PIC16C72A Rev. A Silicon Errata Sheet

The PIC16C72A (Rev. A) parts you have received conform functionally to the Device Data Sheet (DS35008A), except for the anomalies described below.

FIGURE 1: $\overline{\text{MCLR}}$ EXTERNAL CIRCUIT

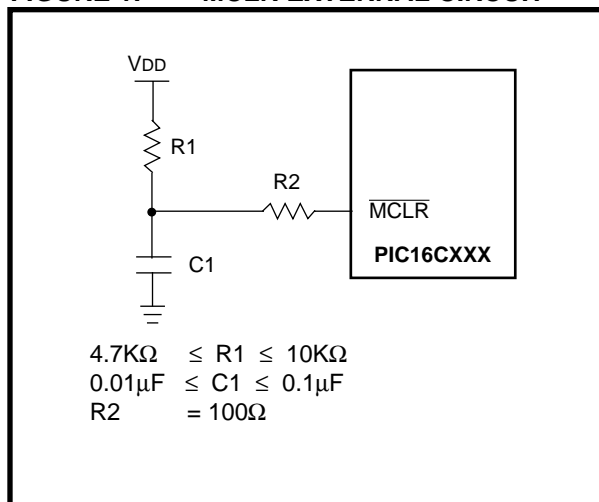
1. Module: RESET

The minimum specification for the $\overline{\text{MCLR}}$ must be met in order to RESET the PIC16CXXX. If a $\overline{\text{MCLR}}$ pulse occurs that is less than the minimum specification (parameter #30), improper device operation can occur.

If the Minimum specification cannot be met, then an external circuit must be used to insure that any pulse width less than the specification will be filtered before it reaches the $\overline{\text{MCLR}}$ pin.

A possible circuit is shown in Figure 1. Proper design validation needs to be done to ensure desired operation over the applications operating conditions

Figure 1: Wake-up from Sleep

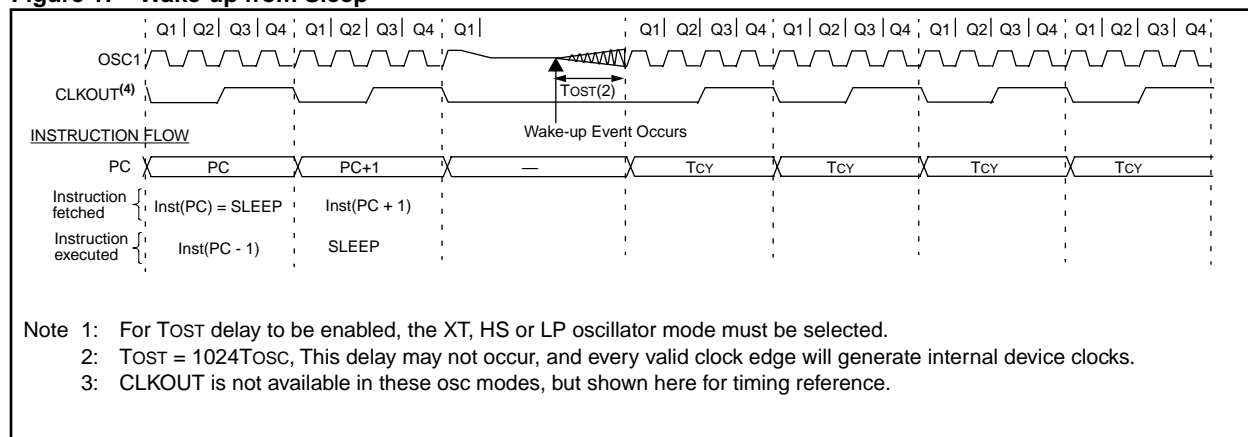
2. Module: OSCILLATOR

The Oscillator Start-up Timer (TOST) delay may not occur when the device wakes-up from sleep.

Figure 1 shows the start-up of the crystal after the event that causes the device to wake up from sleep mode (as specified in device data sheet). The start-up time (TOST) may not occur.

After the SLEEP instruction, do a software delay of 256 Tcy (same as 1024 TOSC). At the Reset and Interrupt vector addresses, test to see if the device woke from sleep (the $\overline{\text{TO}}$ and $\overline{\text{PD}}$ bits), and if the device did wake from sleep, ensure that the total cycle delay is 256 Tcy.
